**Town of Rotterdam
Planning Commission
February 17, 2026**

DPW Comments
February 17, 2026

**Re: Three Lot Subdivision
Fort Hunter Road
Project #5755A**

Re: Warehouse/Office Buildings
785 Burdeck Street
Town of Rotterdam
ABD Project #5932A

SUBDIVISION / LOT LINE AMENDMENT PLAN

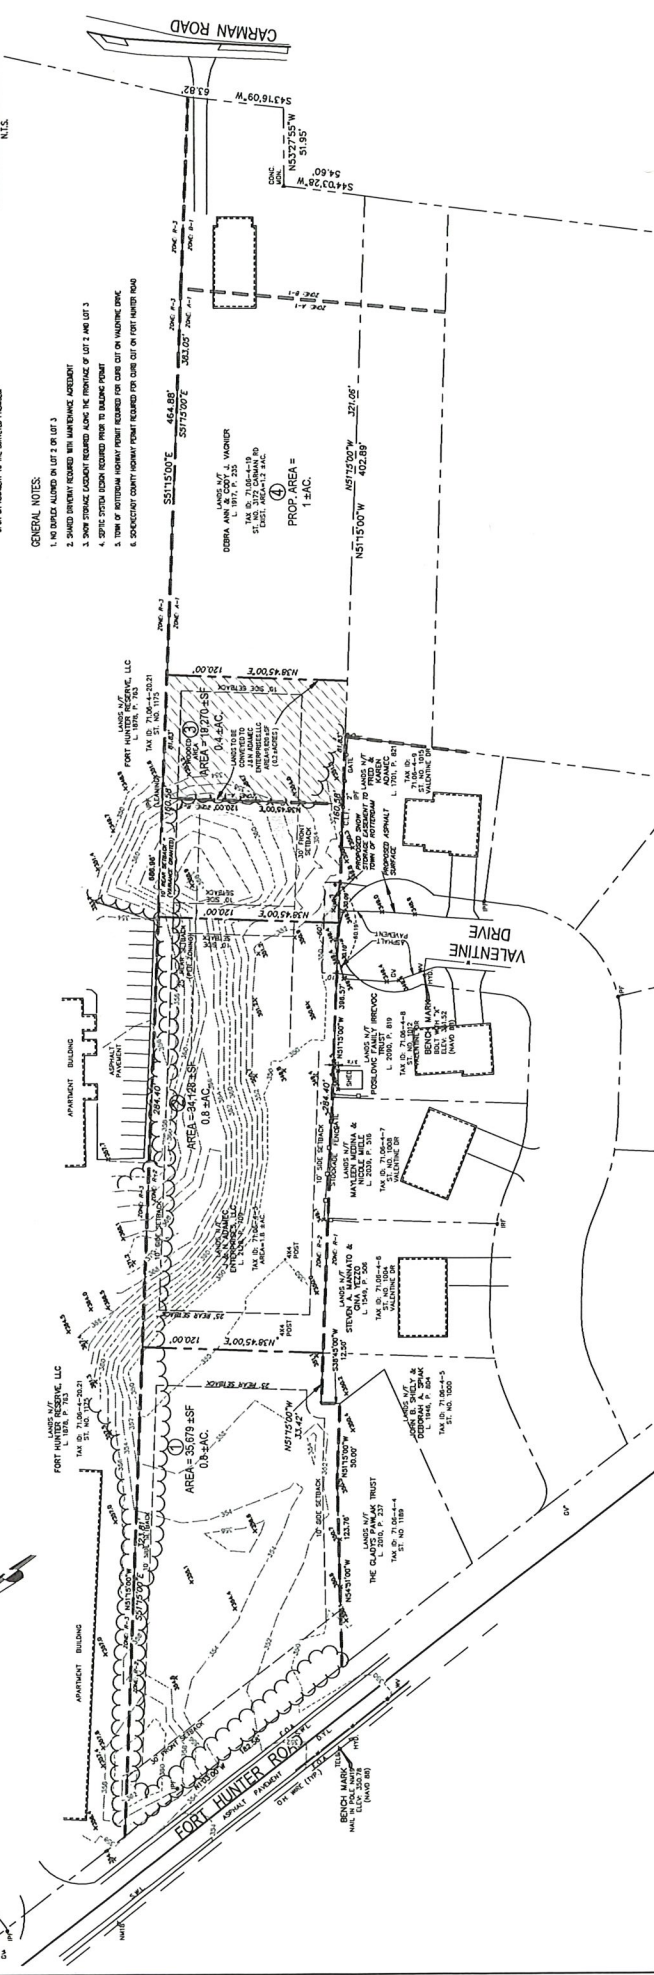
1. See comment response letter from Luigi Palleshi with ABD Engineers dated October 17, 2025.
2. Provide draft maintenance agreement for review by DPW and Attorney for the Town prior to resubmittal.
3. Provide draft snow storage easement to the Town for review by DPW and Attorney for the Town prior to resubmittal.
4. Detail new proposed asphalt in the Town ROW.

5. Change note under Zoning Table to read. "Variances for lot width for Lot #2 & #3 were granted by the Zoning Board of Appeals on June 18, 2025."
6. Are basements proposed? If so, provide elevations.
7. Waterline & proposed shutoff valve for Lot #2 should be relocated out from under the proposed driveway.

4. *Detail new proposed asphalt in the Town ROW.*
Asphalt detail added to the plans.
5. *Change note under Zoning Table to read "Variances for lot width for Lot #2 & #3 were granted by the Zoning Board of Appeals on June 18, 2025."*
Variance note revised as requested.

6. *Are basements proposed? If so, provide elevations.*
Yes, basement floor elevation added to the plans.
7. *Waterline & Proposed shutoff valve for Lot #2 should be relocated out from under the proposed driveway.*
Waterline has been adjusted as requested.
